KMR.CDD.CiQ.1921-1922.01

RE: BUILDING ON PLOT NO. 2-B, F-7 CIVIL LINES QUARTERS.

RE: AMENDED PLANS FOR THE PROPOSED BUILDING ON PLOT NO. 2-B, F-7
CIVIL LINES QUARTERS.

PROPOSED BUILDING

PROPOSED BUILDING

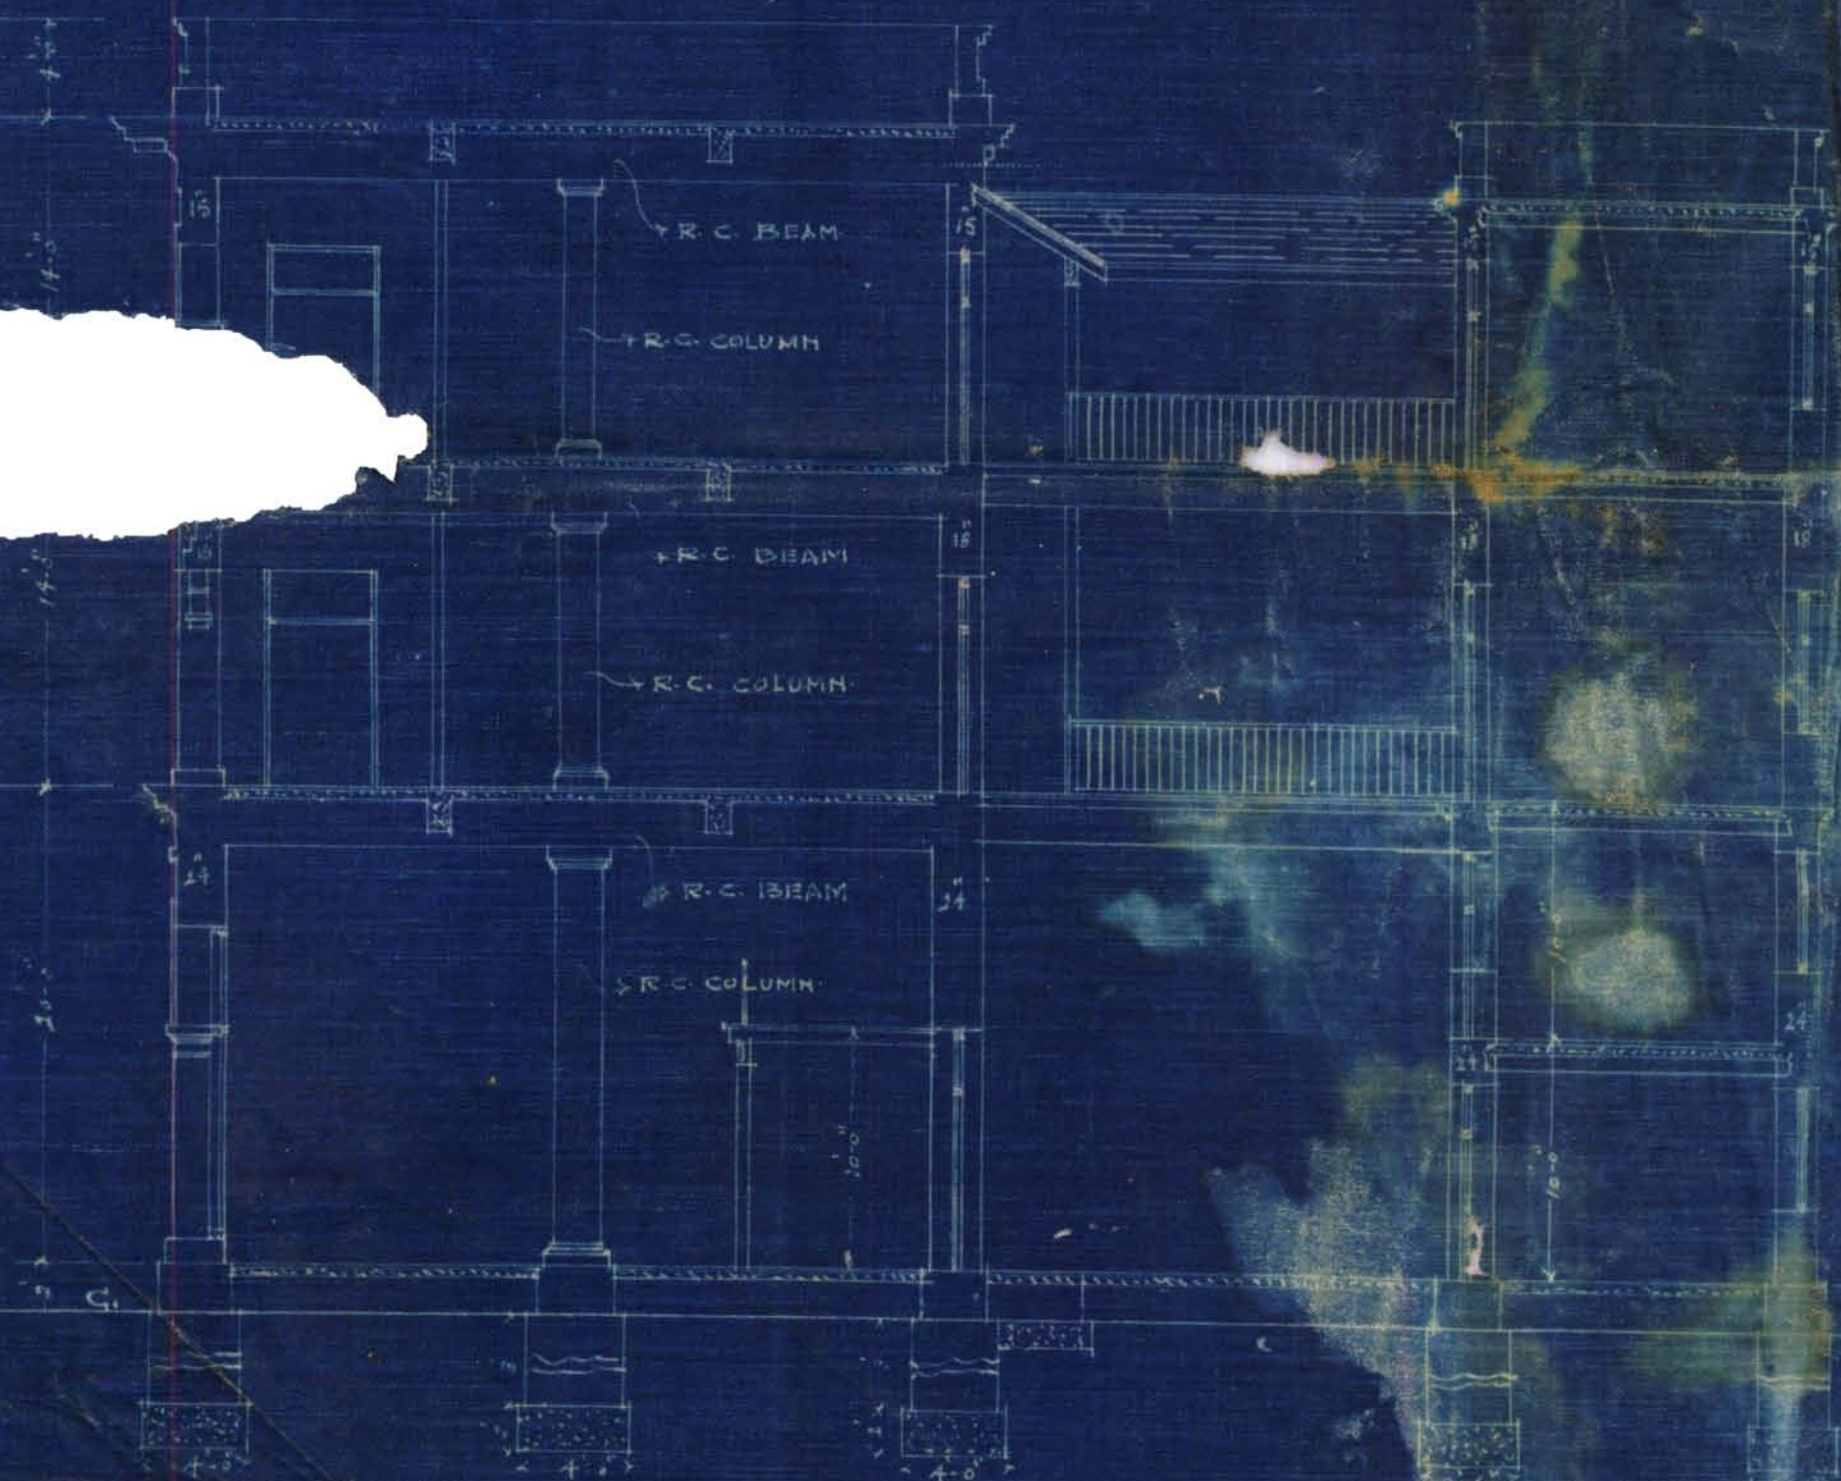
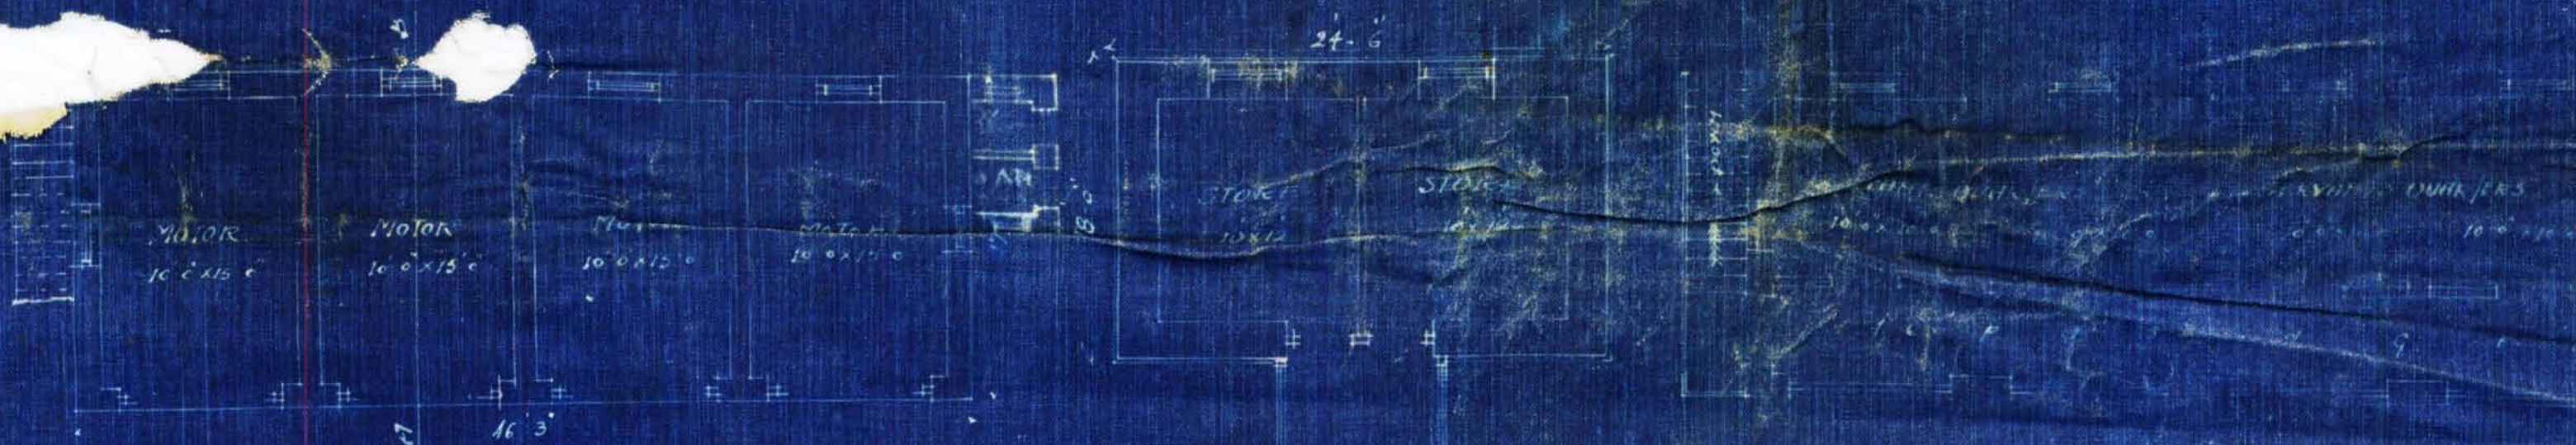
With reference to his application dated 31st May 1921 with plan for the proposed buildings on plot No.2-B F-7 Civil Lines Quarter, Undersigned has the honour to inform Khan Bahadur K. H. Katrak that the out-houses should run from East to West .

2/- Sanitary conveniences for out-houses must be provided .

3/- Dimensions of reinforced concrete pillars , beams & slabs with sketches of reinforcement may please be supplied .

- (1) The position of the out-houses has been changed running from East to West.
- (2) Sanitary conveniences for the out-houses have been provided.
- (3) The details of the r.c.flooring, beams, etc. will be submitted in course of time. In the mean time we shall thank you to kindly approve the plans.
